Re: Minor Project Refinement No. 1 for the South Orange County Reliability Enhancement Project.

South Orange County Reliability Enhancement Project CPUC Minor Project Refinement Form

**MPR-1 FIGURE 1
SAN JUAN CAPISTRANO SUBSTATION
BRUSH CLEARING**

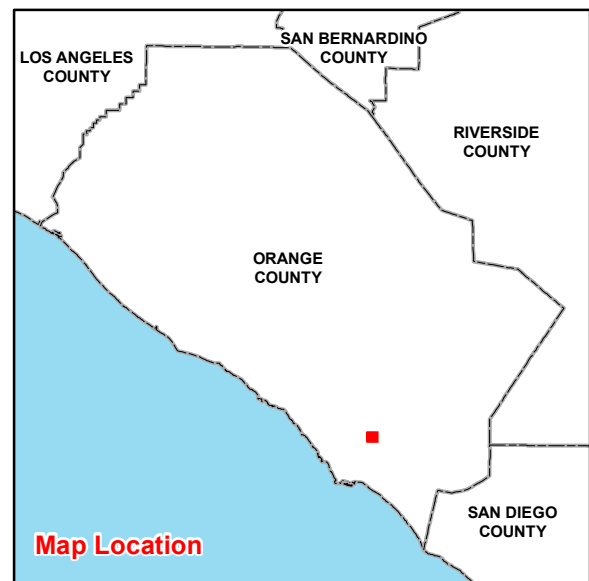
- Justification for change: Following final design and constructability review in the field, the construction contractor identified the need to gain access on to the adjacent properties in order to facilitate the construction of the screen wall located on the southern border and the chain-link fence located on the southern and eastern borders of the substation. The wall requires backcuts to install the foundations and access is needed on the outside perimeter for equipment, vehicles and workers. Installation of the chain-link fence only requires construction access. As such, additional temporary workspace is needed for construction of the southern screen wall and installation of the chain-link fence.

- Maps & Figures: Refer to Figure 1 in **Attachment B, Figure** for a map of the MPR-1 proposed temporary workspace area. Refer to **Attachment C, MPR-1 Site Photographs**, for pictures of the current conditions within the MPR-1 temporary workspace area.
